ILLUSTRATIVE SITE DESIGNS
FOR
MULTI-FAMILY HOUSING IN PASADENA

Prepared for the Pasadena
Multi-Family Housing Task Force

Daniel Solomon and Associates
Daniel Solomon
Kathryn Clarke
Susan Haviland

DSA 48.9

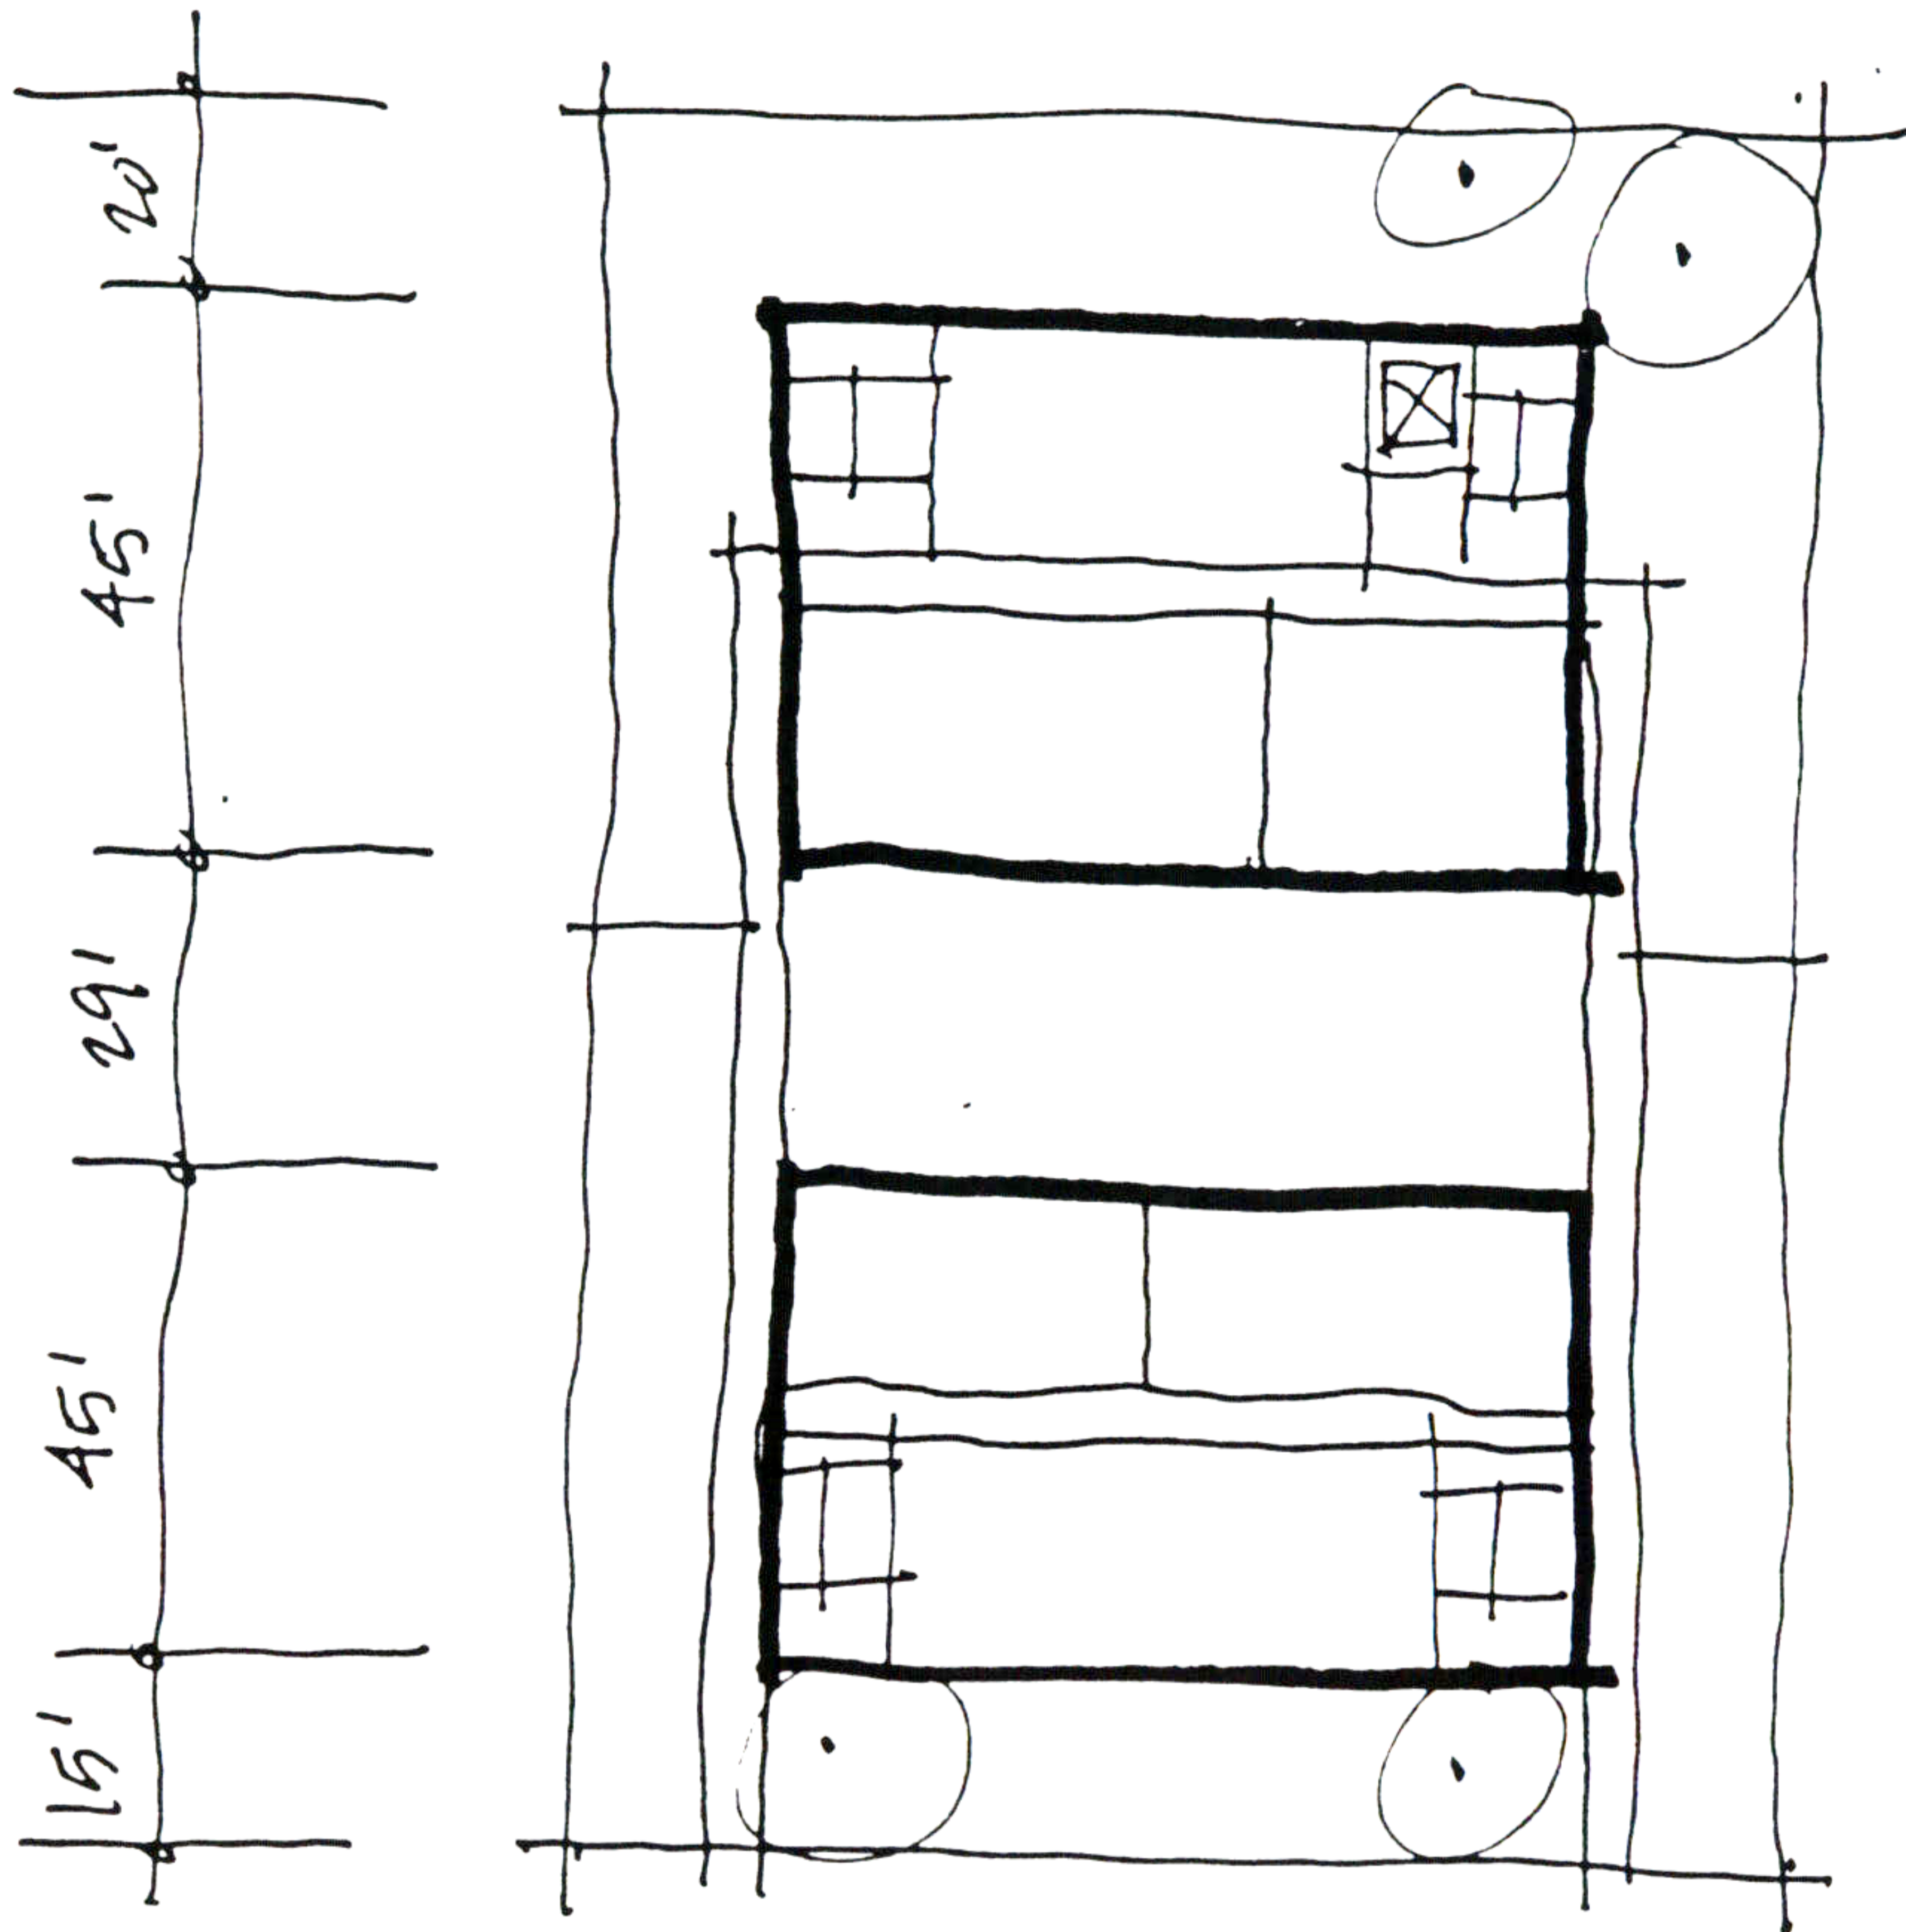
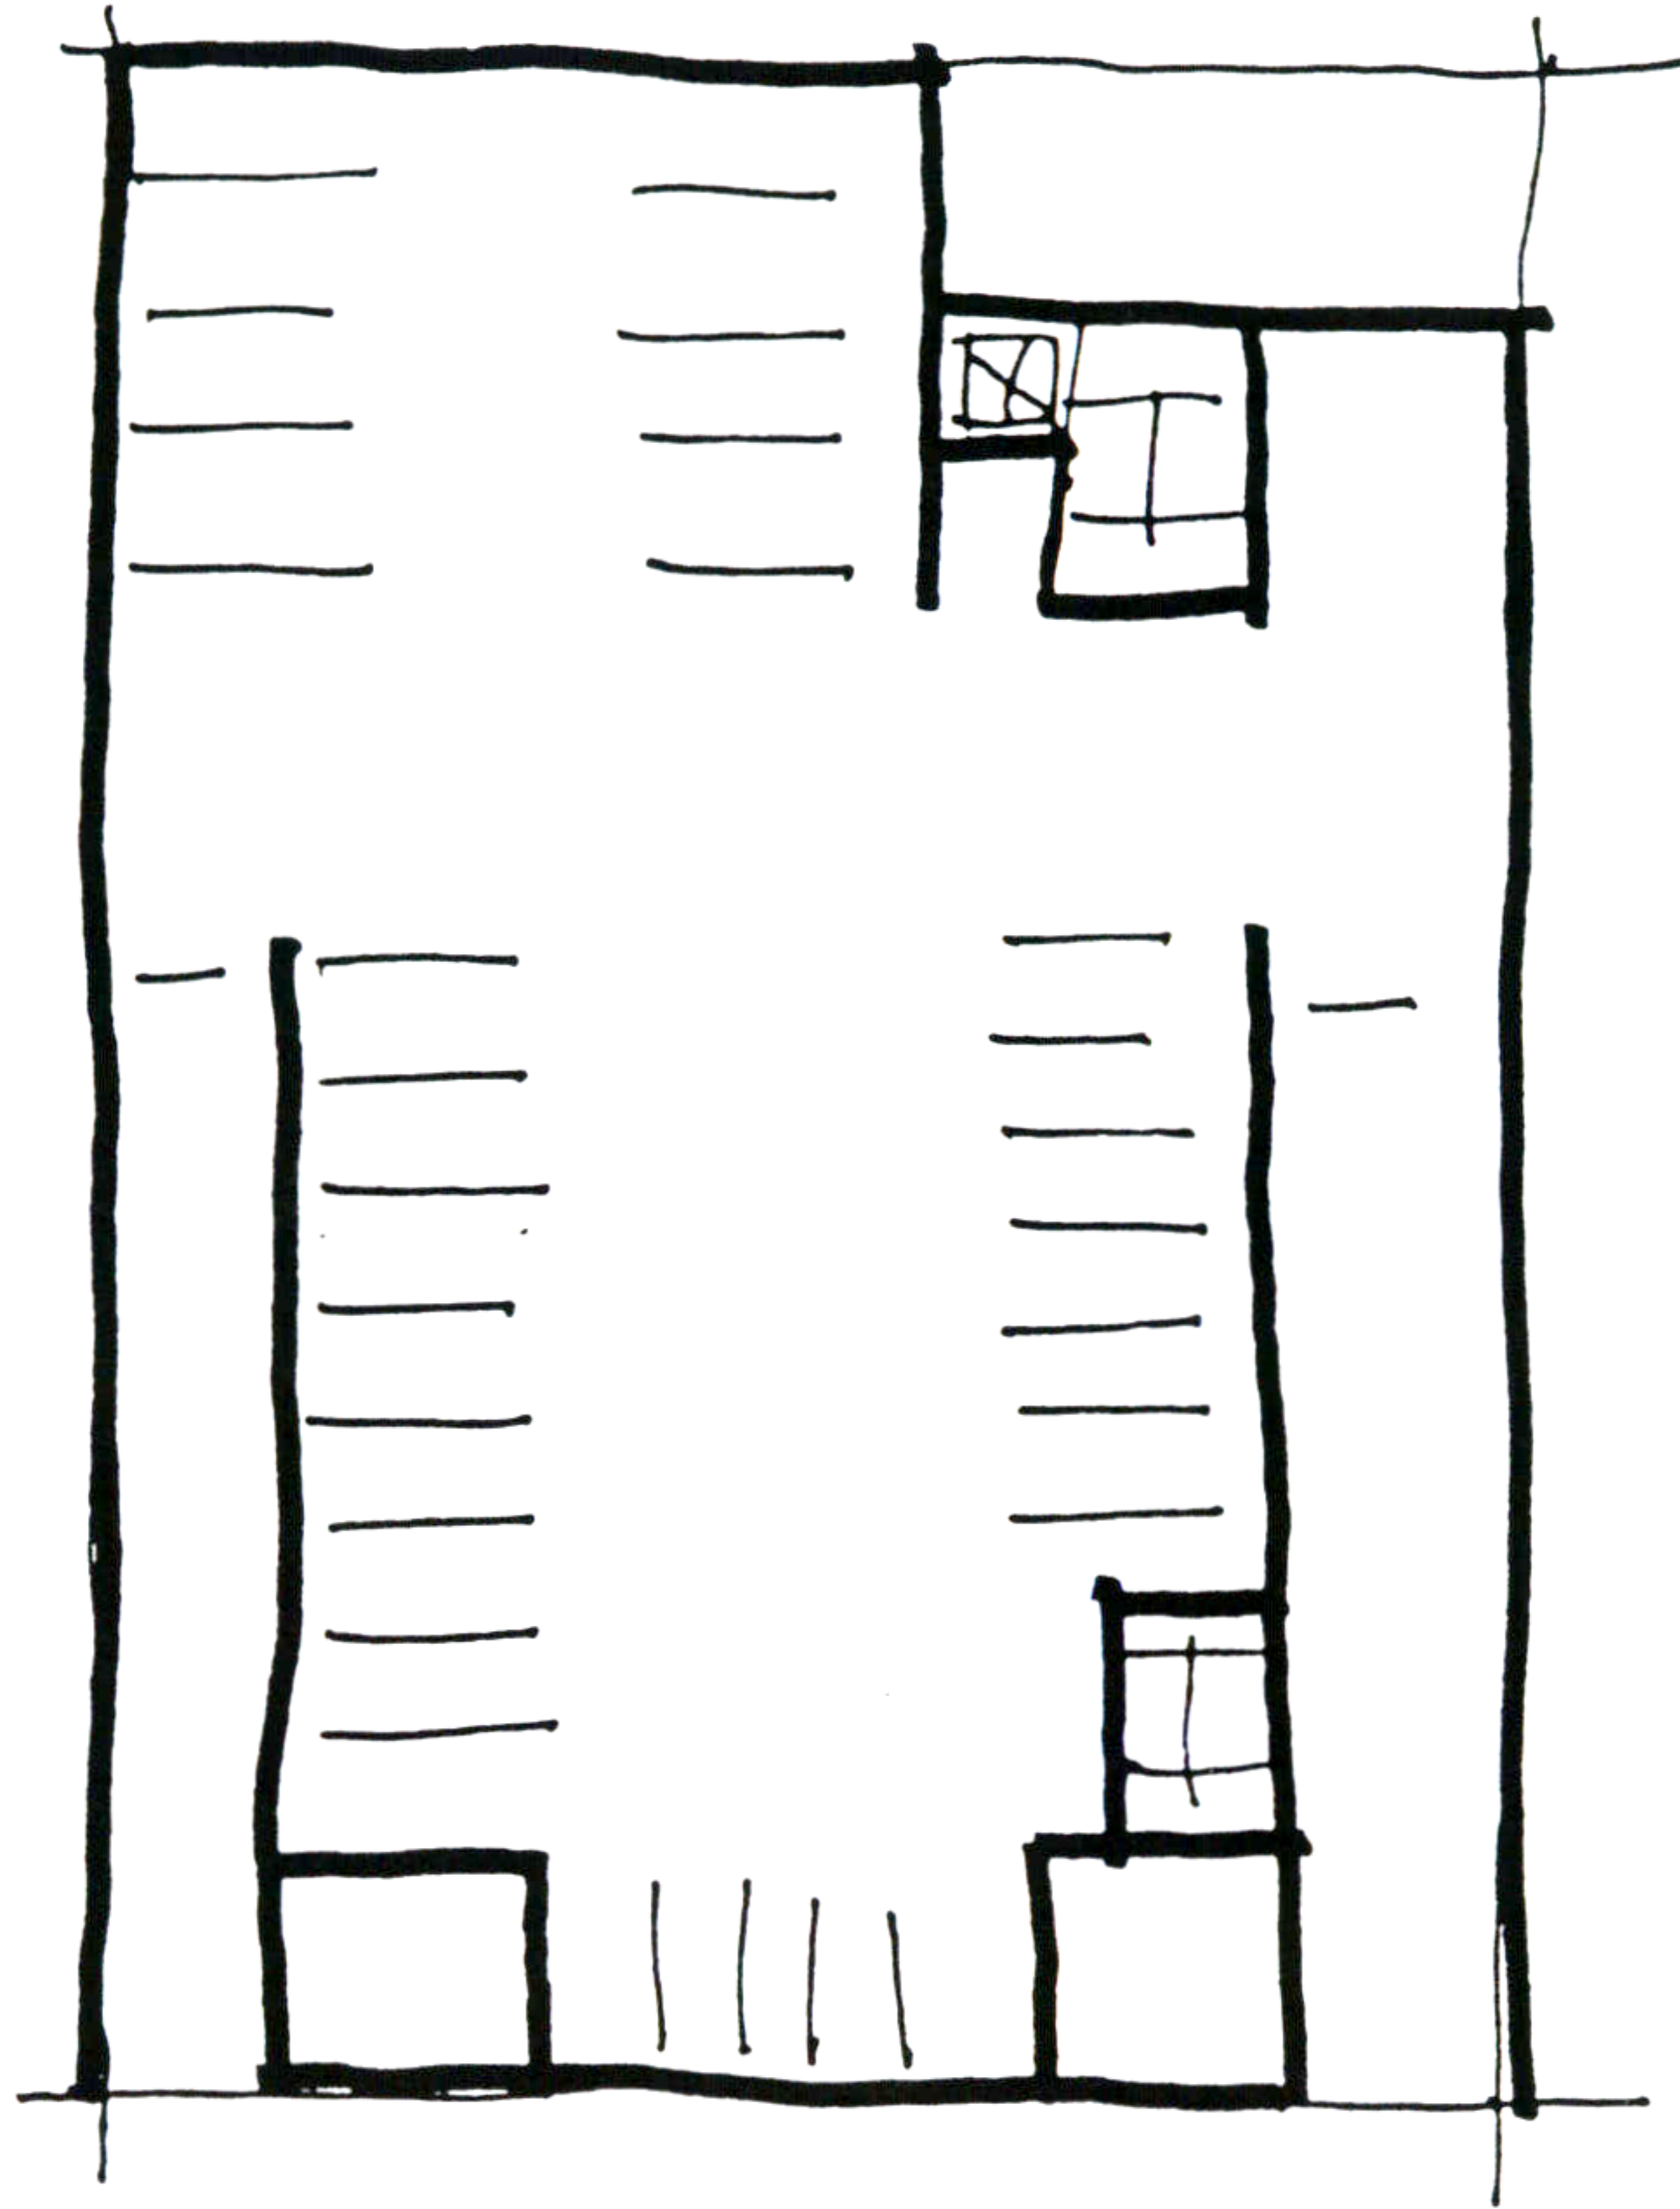
Not acceptable
